Canoga Transportation Corridor

Final Environmental Impact Report Addendum

December 15, 2008

Figure 3-1. Illustration of the Canoga Busway Option 5

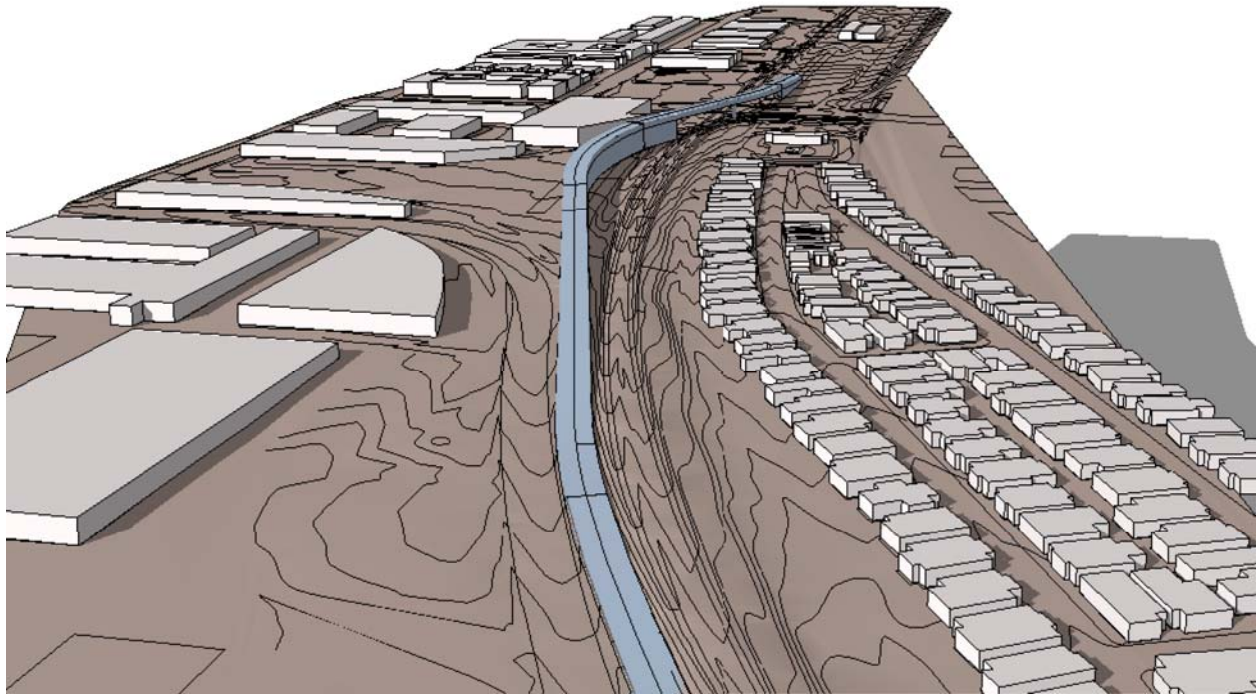
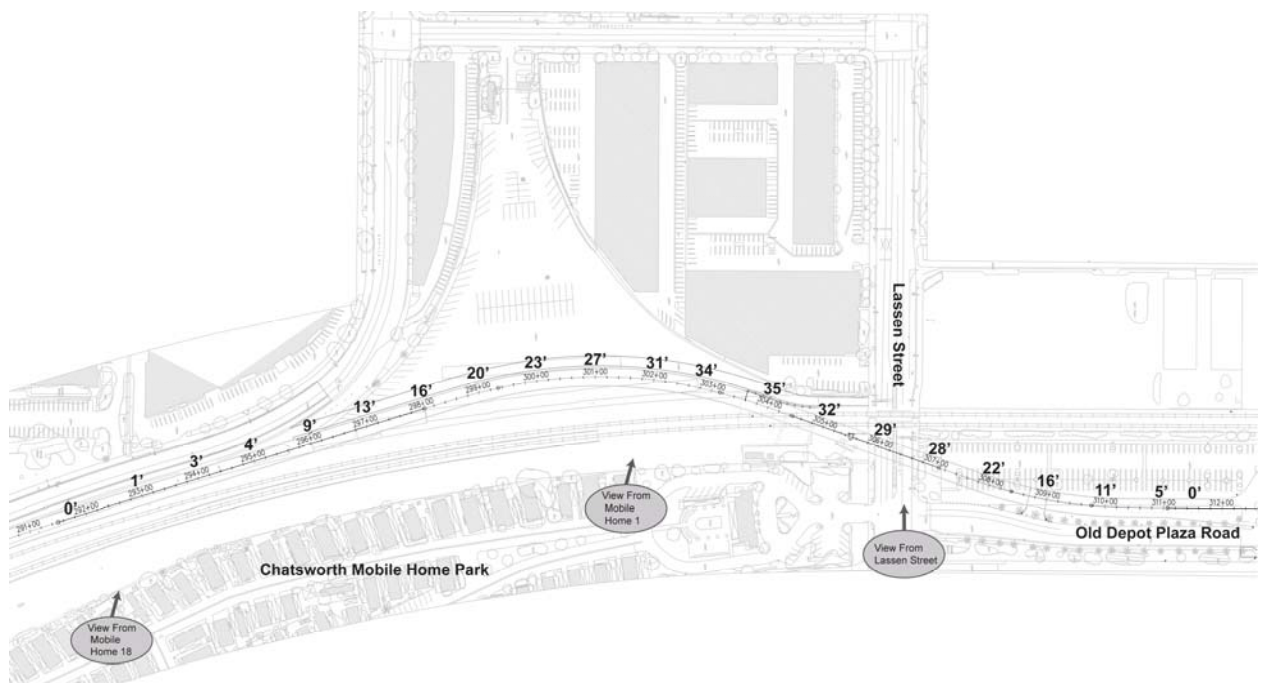
In response to the comments submitted on this issue and in recognition of the desire to reduce the massing of the Lassen Street/Railroad overcrossing and approach, the consultant team further clarified the analysis of the visual environment and potential mitigation measures based on the Preliminary Engineering Plan and Profile drawings of Option 5 bridge, which was selected as the locally preferred alternative. **Figure 3-1** is a 3d illustration showing the relationship of the overcrossing and the embankment leading to the overcrossing. **Figure 3-1a** shows a plan view of the LPA on the west side of the railroad tracks away from the mobile homes. The approximate height of the road bed on the embankments and bridge are also shown.

Public Right-of-Way - Lassen Street is a public right-of-way and currently there are views of the Santa Susana Mountains to the west as shown in existing condition photos. See **Figure 3-1b** taken from the entrance to the mobile home park, south of Lassen Street. **Figure 3-1c** is a view standing on the sidewalk at the mobile home park entrance with the proposed bridge over Lassen Street; Santa Susana Mountains are visible under the bridge. Further east from the bridge on Lassen Street, the bridge would temporarily block views of the mountains for motorists and pedestrians. Overhead utility poles/lines directly under/adjacent to the bridge will be undergrounded, some billboards potentially removed, and railroad gates and lights potentially relocated thereby improving the overall visual environment. Potential mitigation (see MM 4.6-5) for the massing of the bridge structure would be to provide variations in the shape of the bridge and railings to create shadow lines and openings. **Figure 3-1c** illustrates a bridge design that is consistent with this mitigation measure.

Figure 4: Replacement Parking for Option B and D north of the Chatsworth Metrolink Station

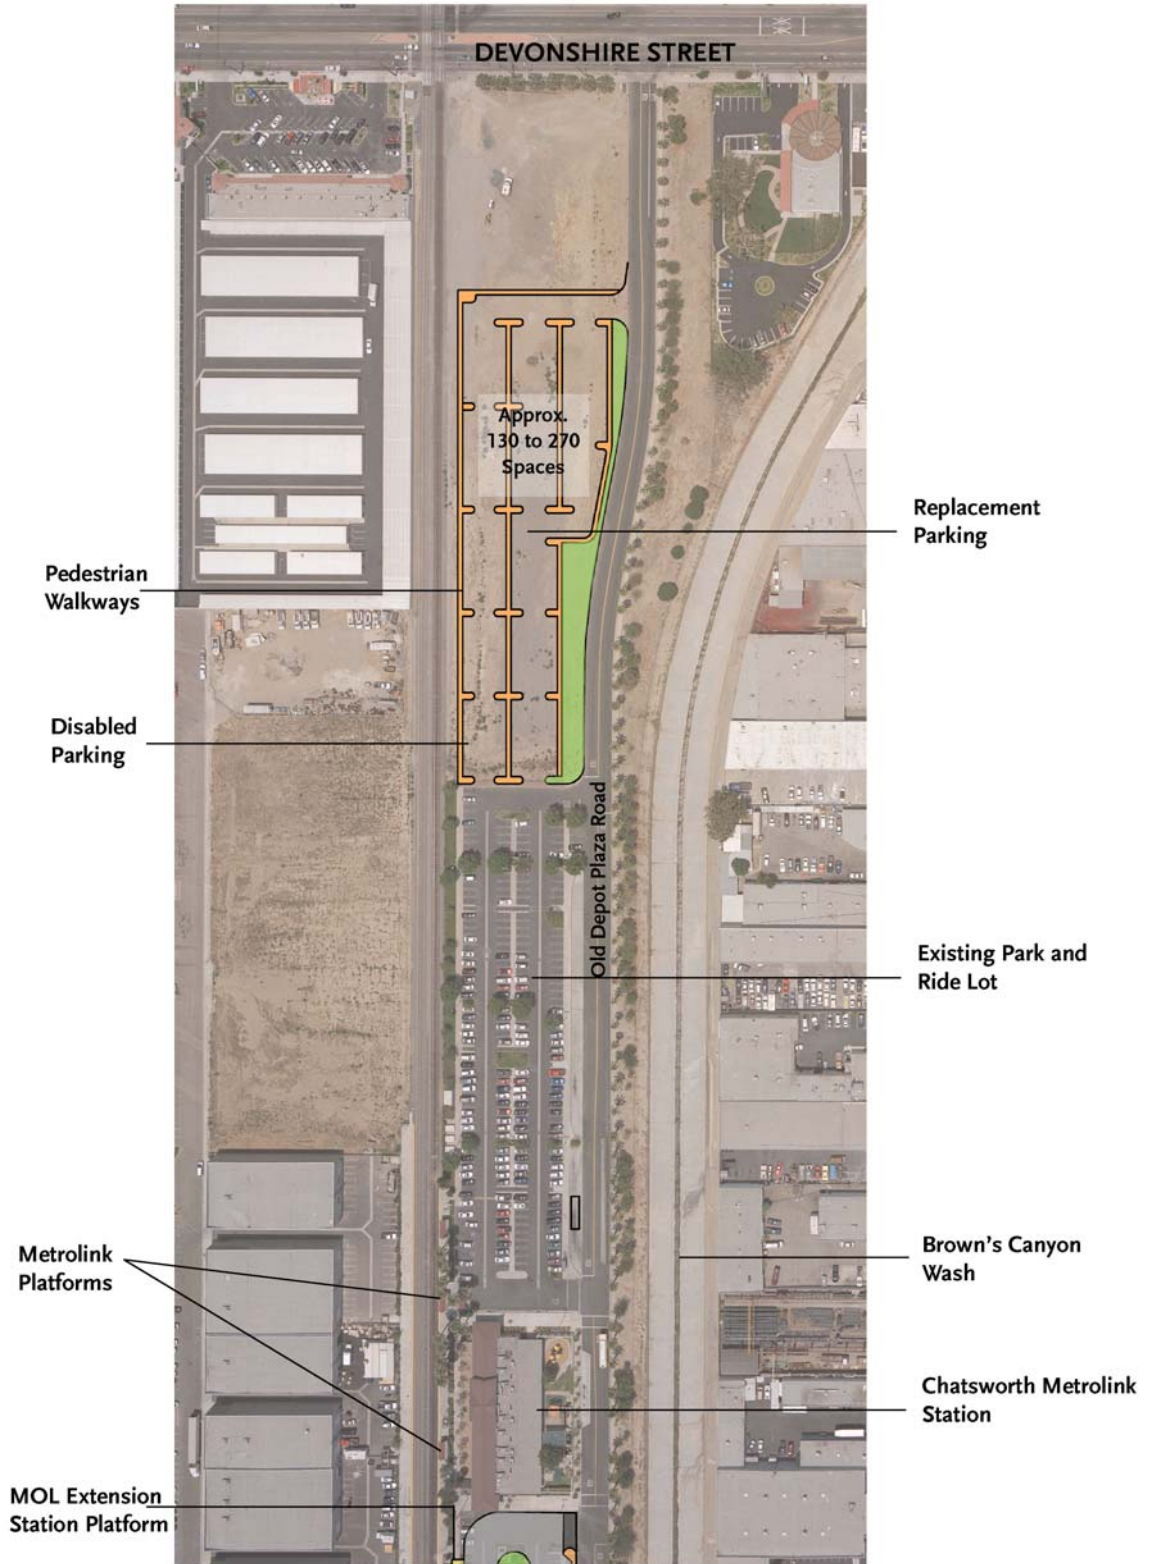
108-5 Please see Topical Responses 1 and 2. As suggested by the commenter an 8 ft privacy wall is under consideration. Parking removed for the overpass would be replaced north of the Chatsworth Metrolink Station, and is illustrated in **Figure 4** on the following page.

The "Marilla" parking lot is conceptually illustrated below:

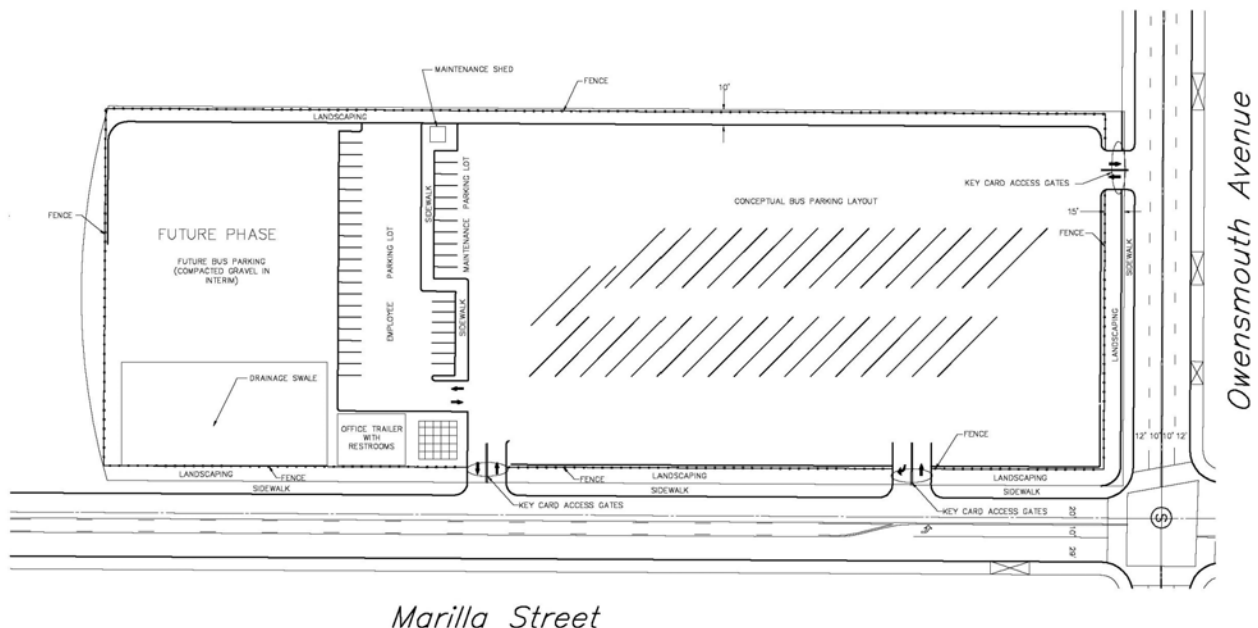
Page 3-54, add the following sentence and graphic at the end the second paragraph:

Revised Figure 4.7-16

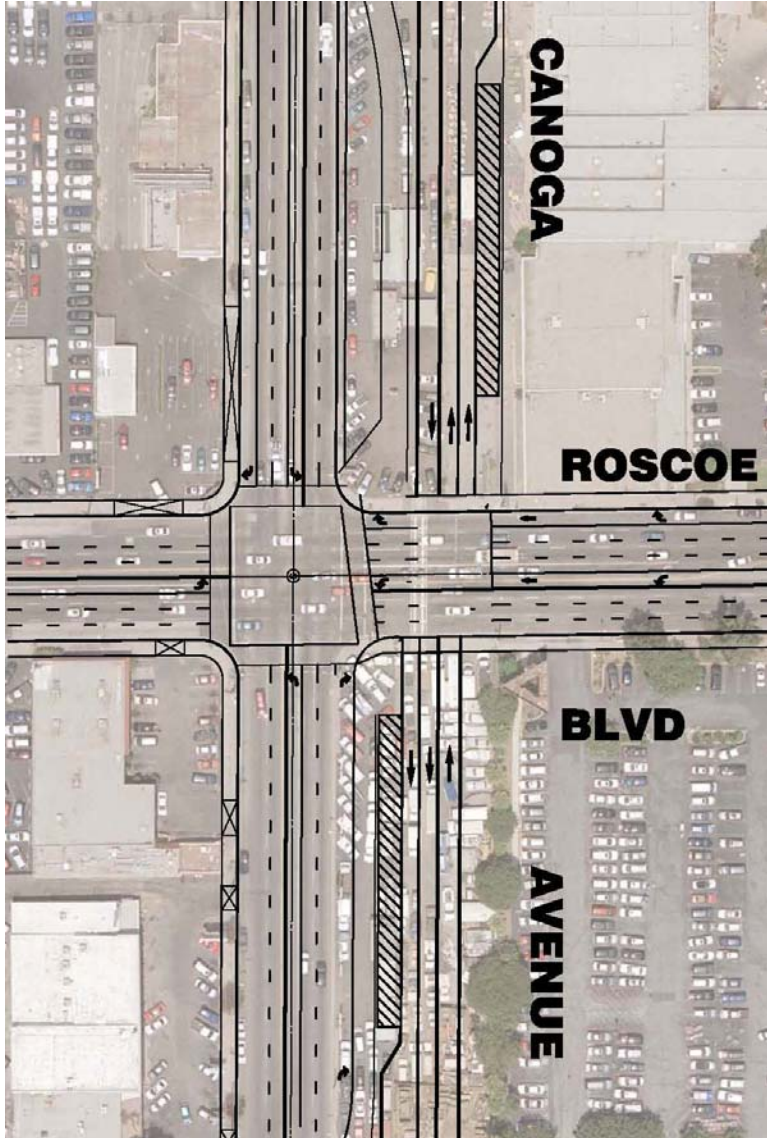
Page 4.7-49, Figure 4.7-16, is revised as shown on the next page.

Revised Figure 4.7-18

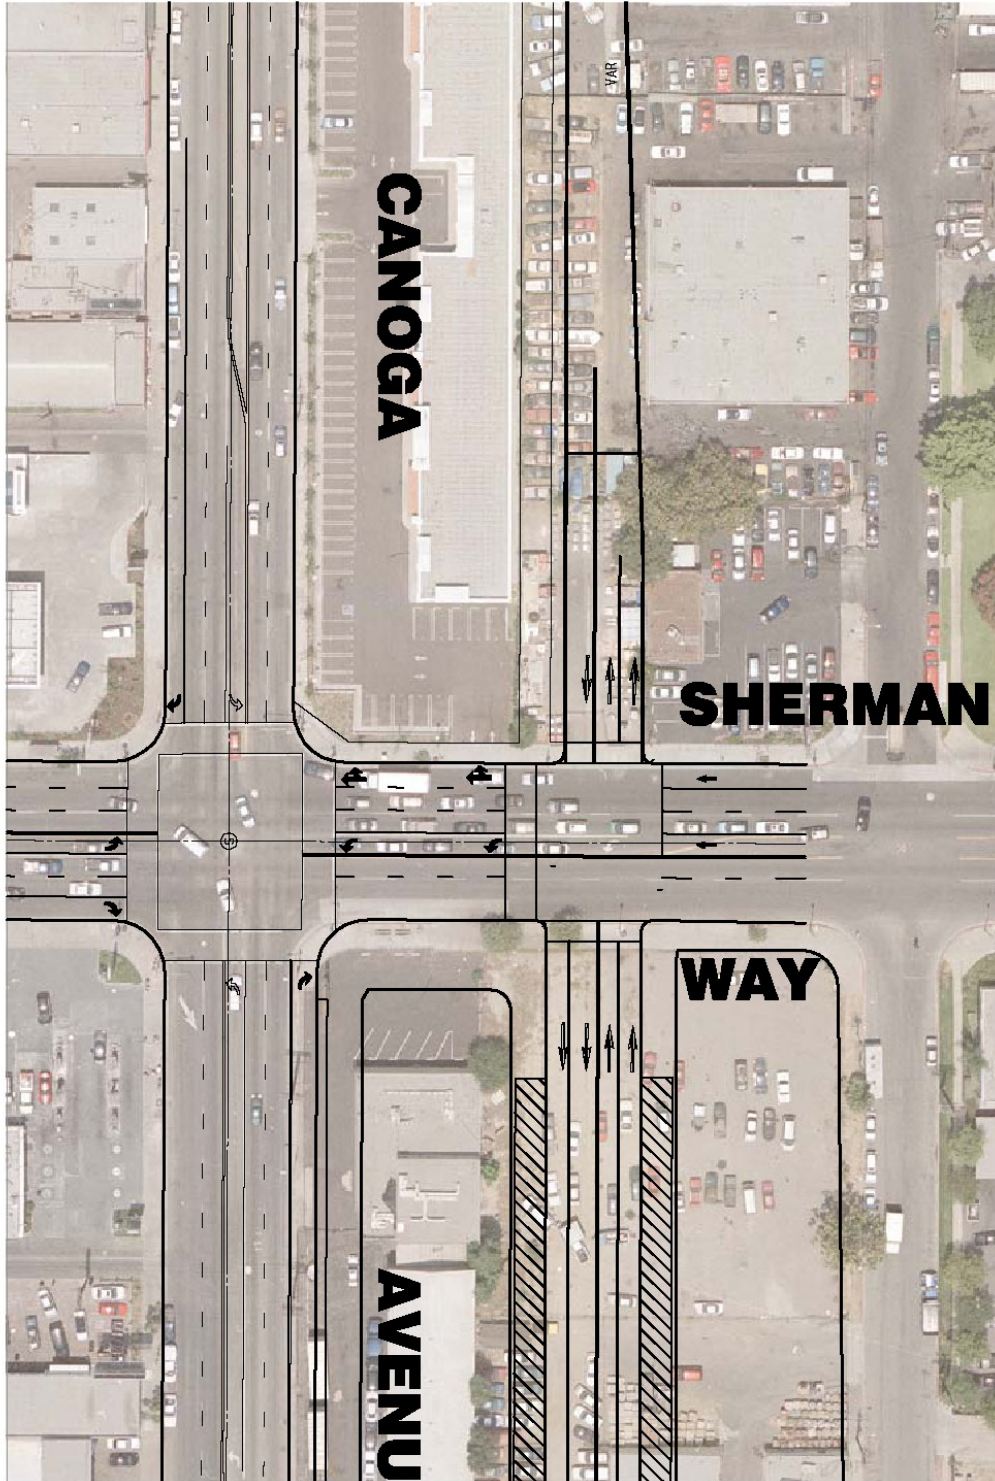
Page 4.7-51, Figure 4.7-18 is revised as shown on the next page.

Revised Figure 4.10-2

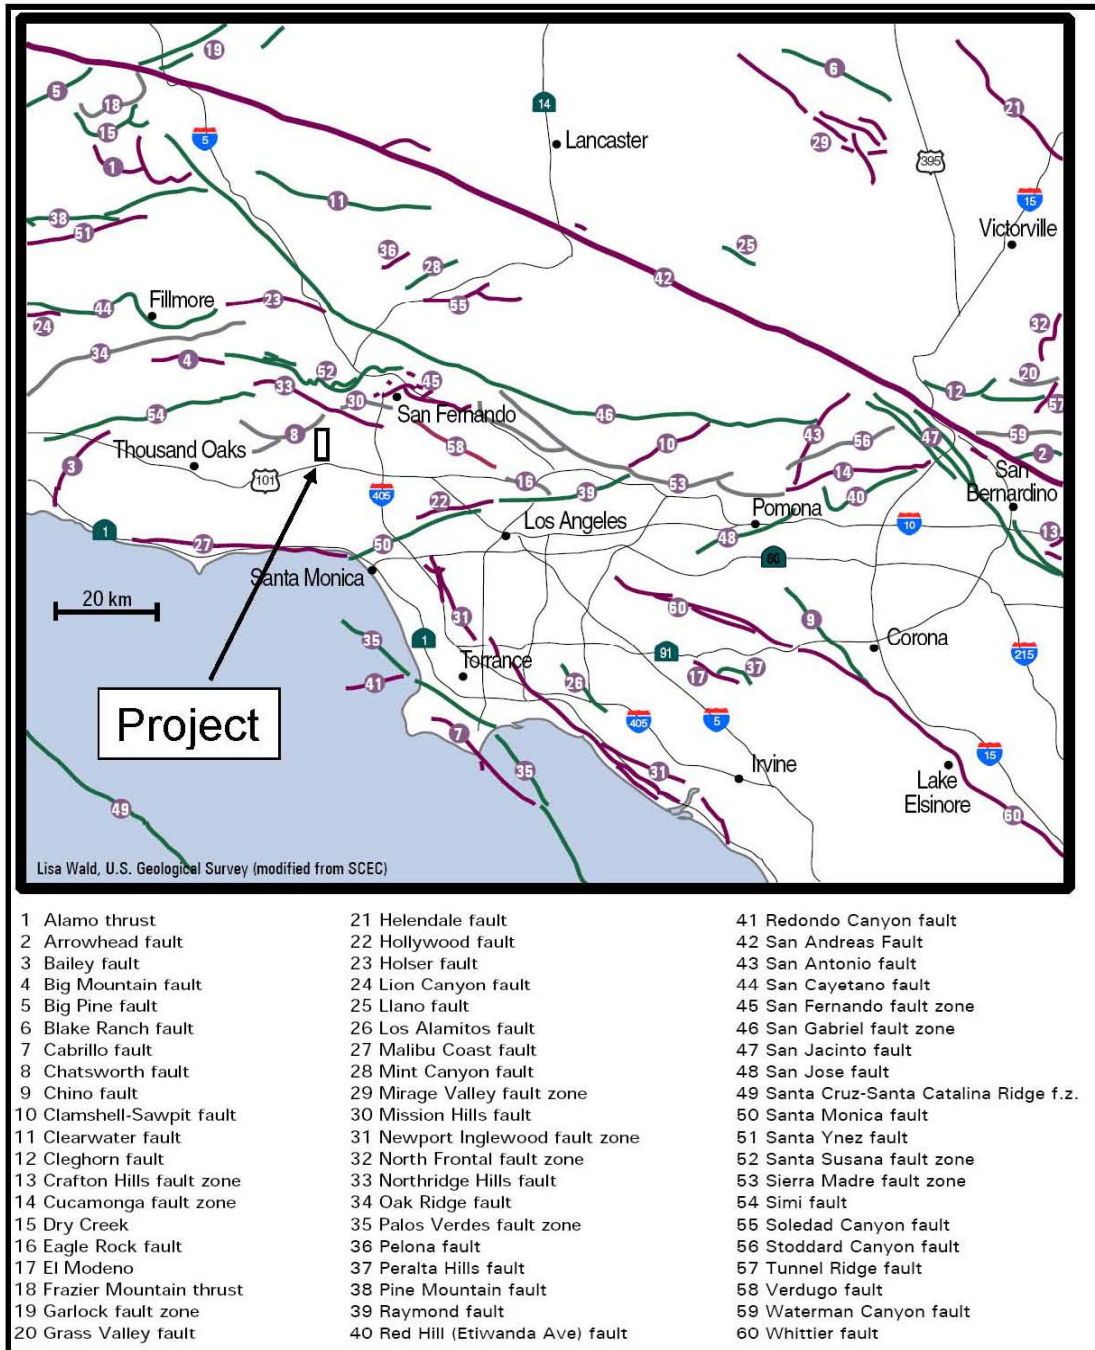
Page 4.10-7, Figure 4.10-2, is revised as shown on the following page.
